Addendum No. 1

Nicetown Park Renovations

Philadelphia Redevelopment Authority

Issue Date: February 26, 2024

TRASH SCREEN
SCALE: NOT TO SCALE

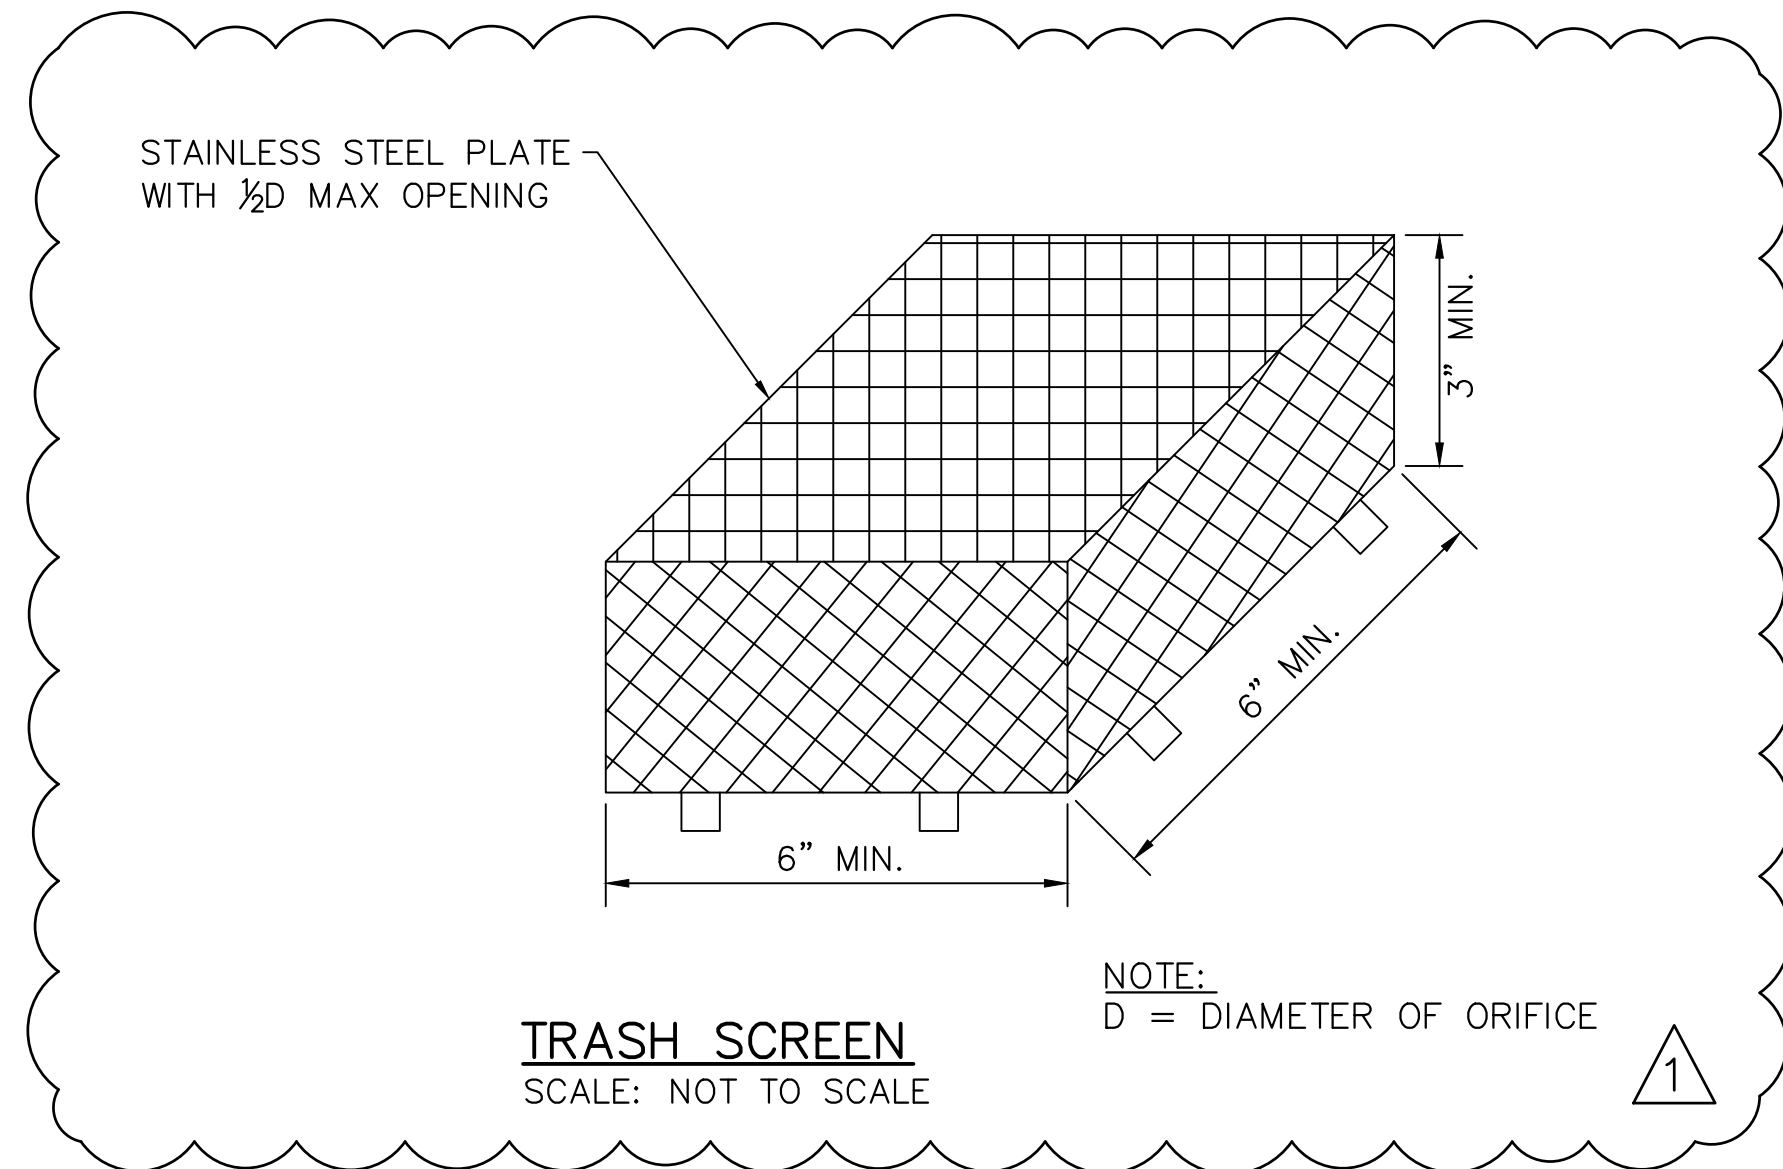
- Added a trash screen detail

MEDIA FILTER
SCALE: NOT TO SCALE

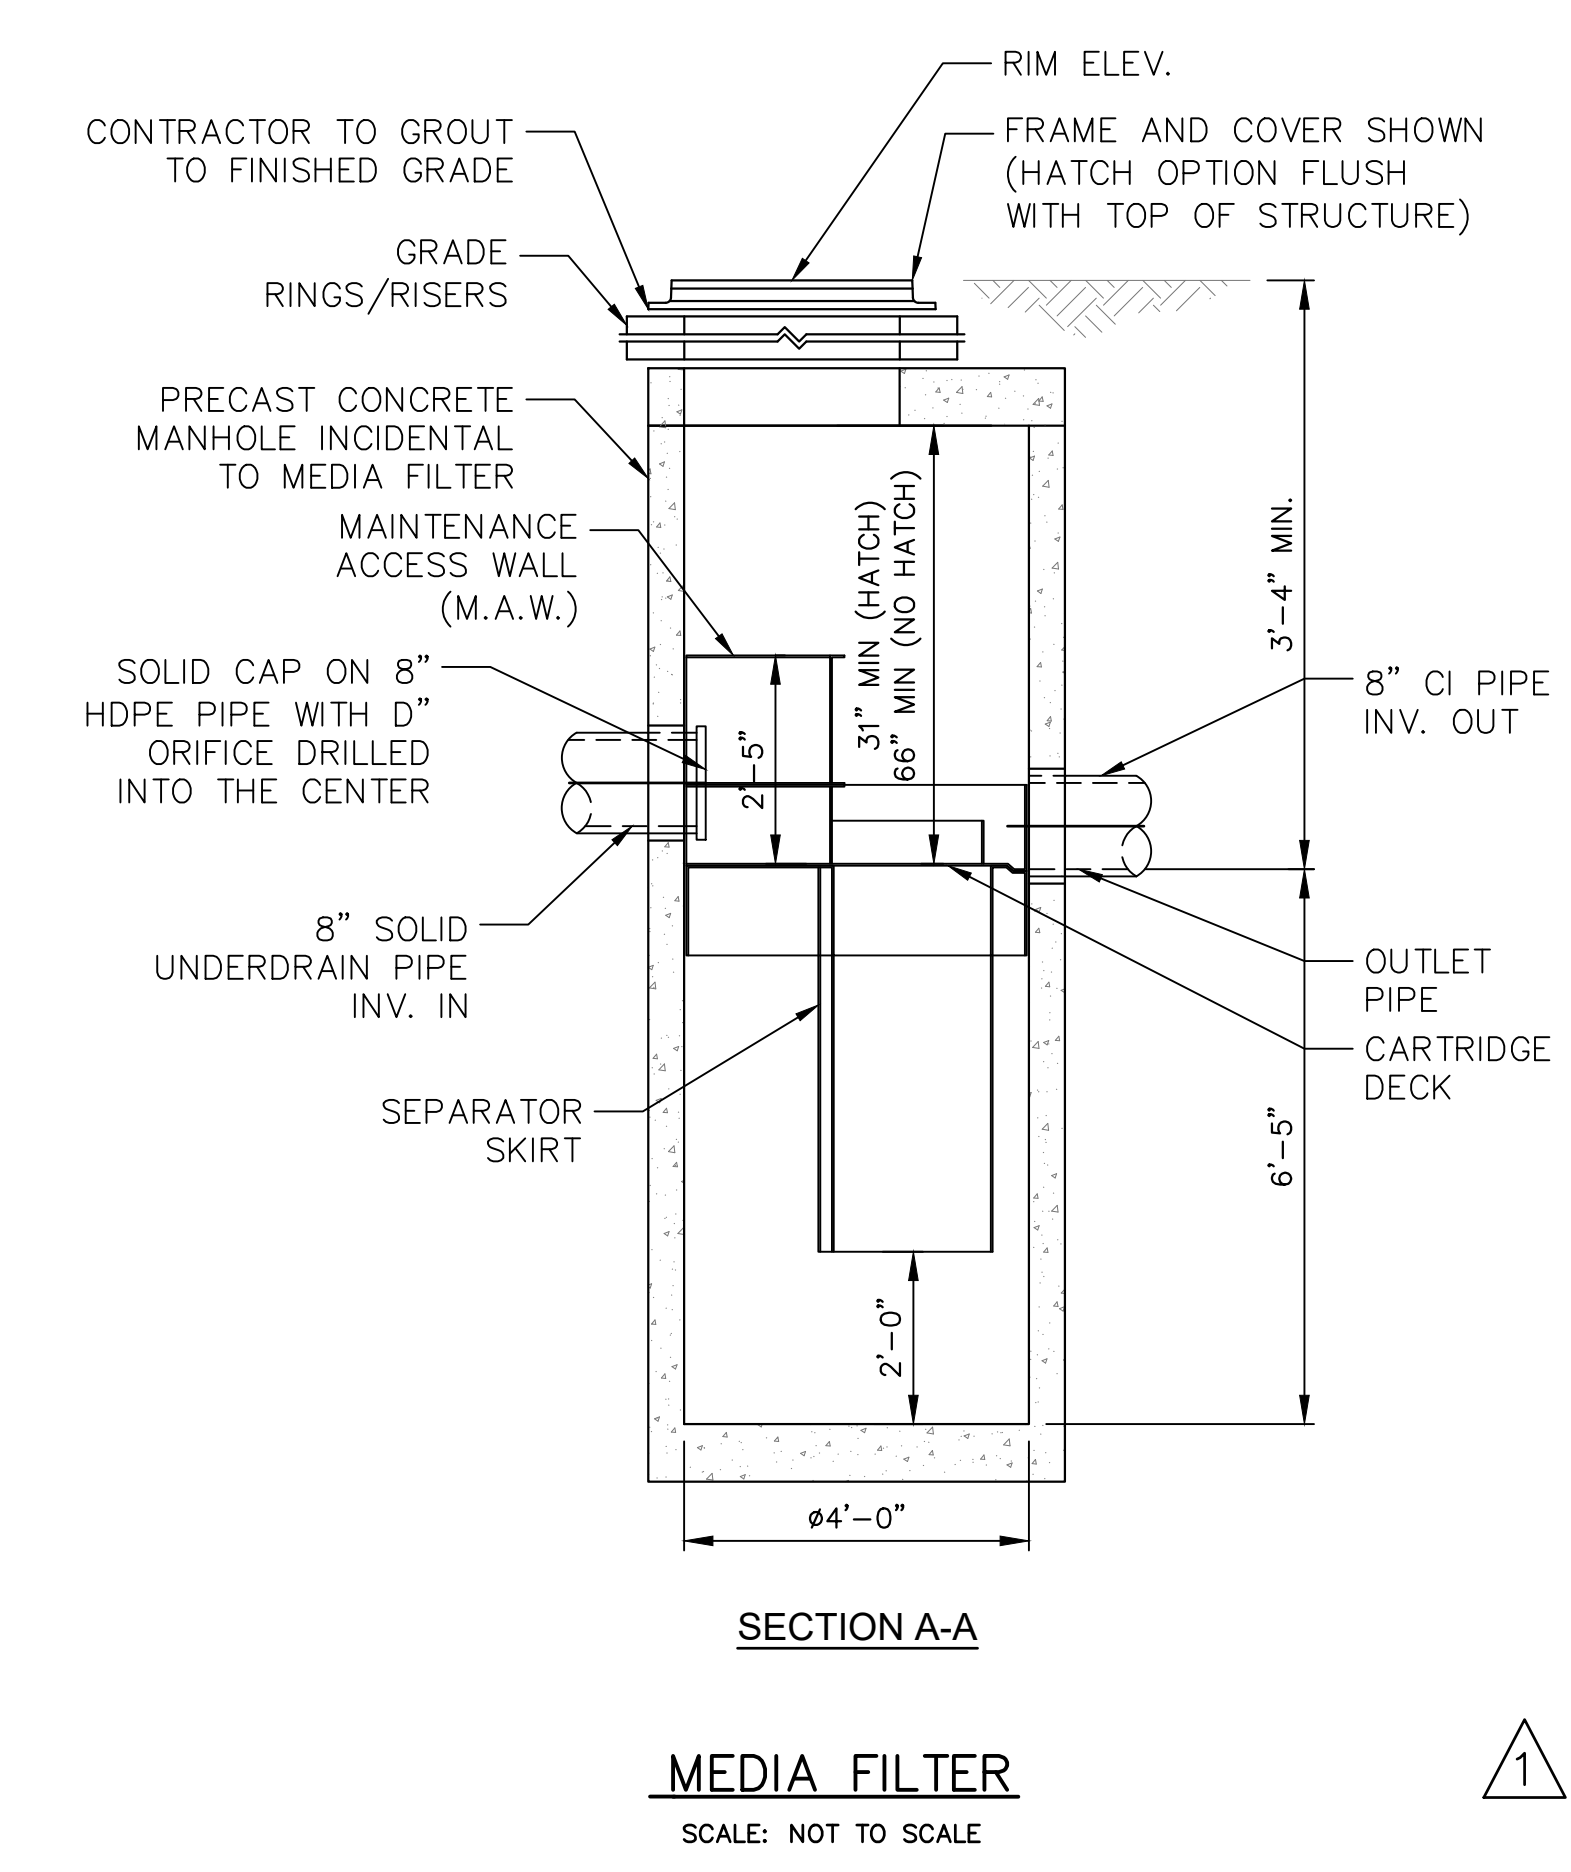
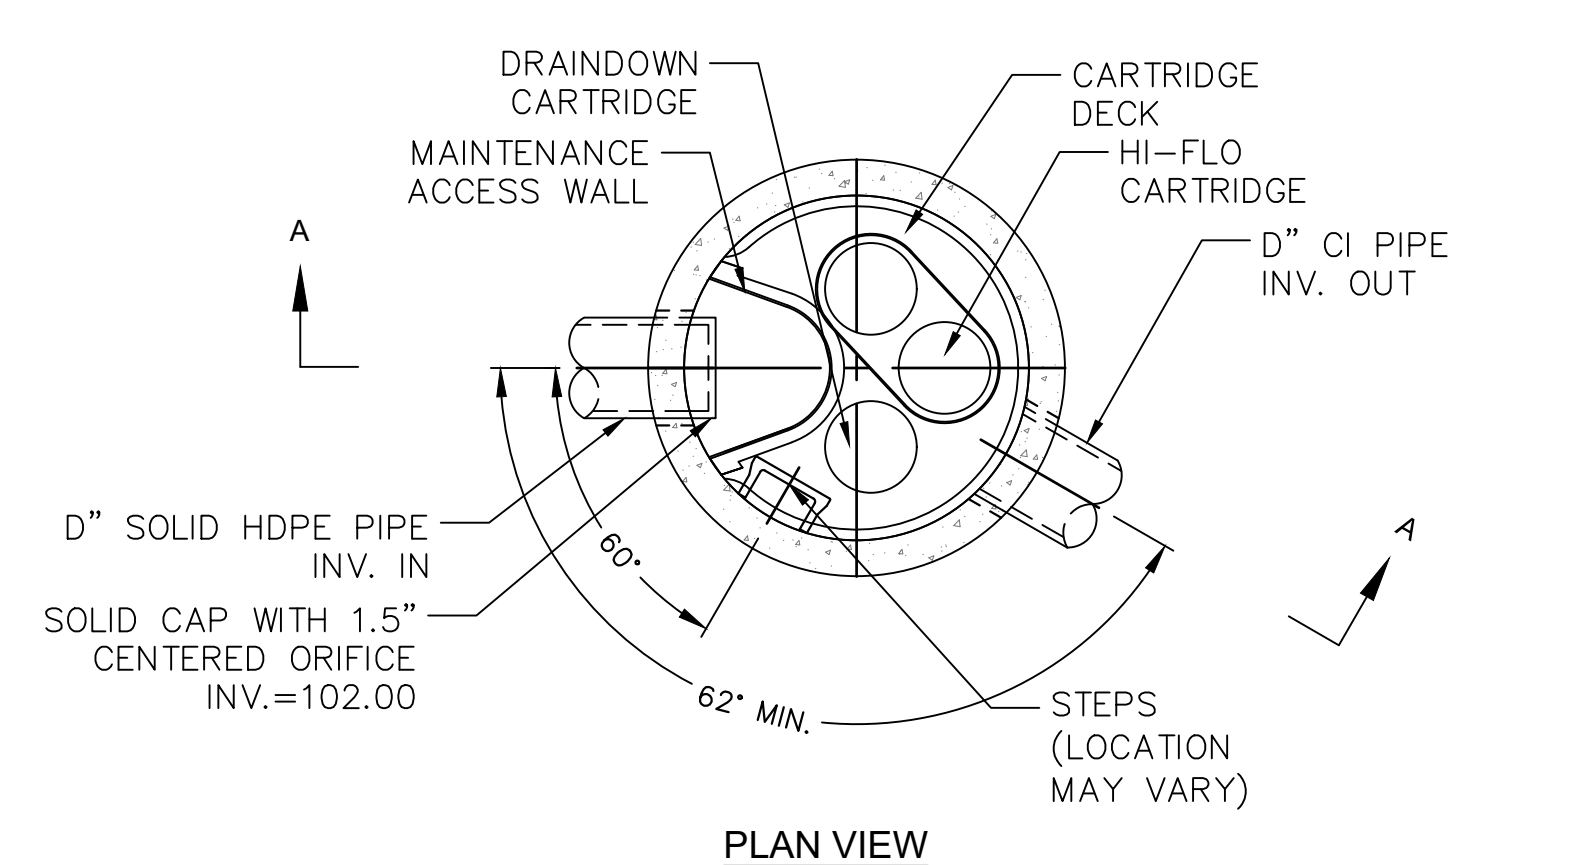
- Added a Media Filter detail
